Floodplain Variance Request 10021 Wild Dunes Drive

Onion Creek Watershed

VARIANCE <u>DENIAL</u> RECOMMENDED SUMMARY of FINDINGS

10021 Wild Dunes Drive Proposed Lot Layout

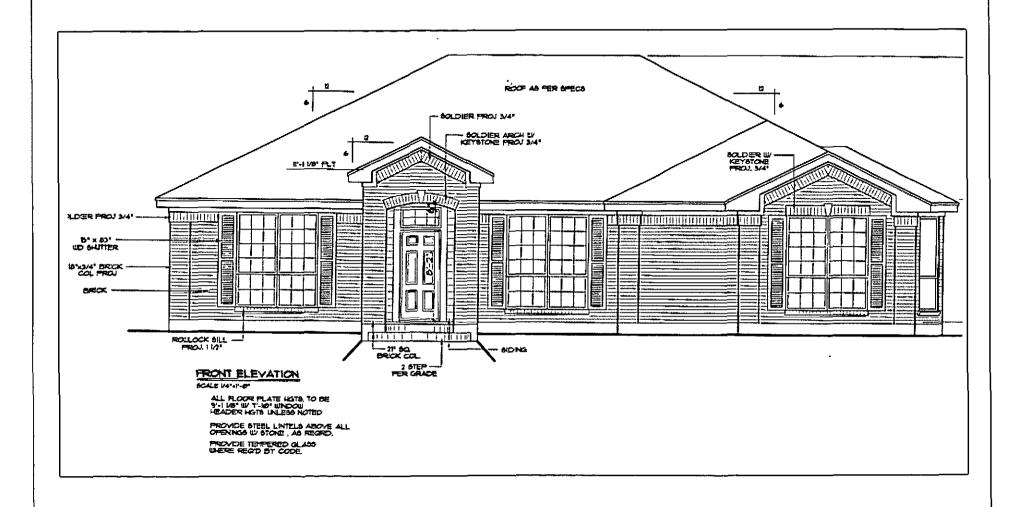
- 1. PROPOSED CONSTRUCTION IS WITHIN THE 100-YEAR FLOODPLAIN OF ONION CREEK. The 100-year floodplain inundates the entire lot.
- 2. NO SAFE ACCESS. For the 100-year flood event, a water depth of 5.8 feet at the street ourb line in front of the house impedes access to the house. The house will be surrounded by up to 3.0 feet of water during the 100-year flood event. Due to water depths in the street, this structure would not be accessible by Austin Fire Department vehicles.

- 2. ADDITIONAL OCCUPANCY IN THE FLOODPLAIN. The proposed construction will increase the opportunity for human occupancy in the floodplain. The proposed house would add 2,144 sq. ft. of conditioned space and a 495 sq. ft. garage.

- 4. FINISHED FLOOR ABOVE MINIMUM REQUIRED ELEVATION. The proposed construction meets City of Austin minimum elevation requirements (proposed elevation is at least one-foot above the 100-year floodplain elevation).
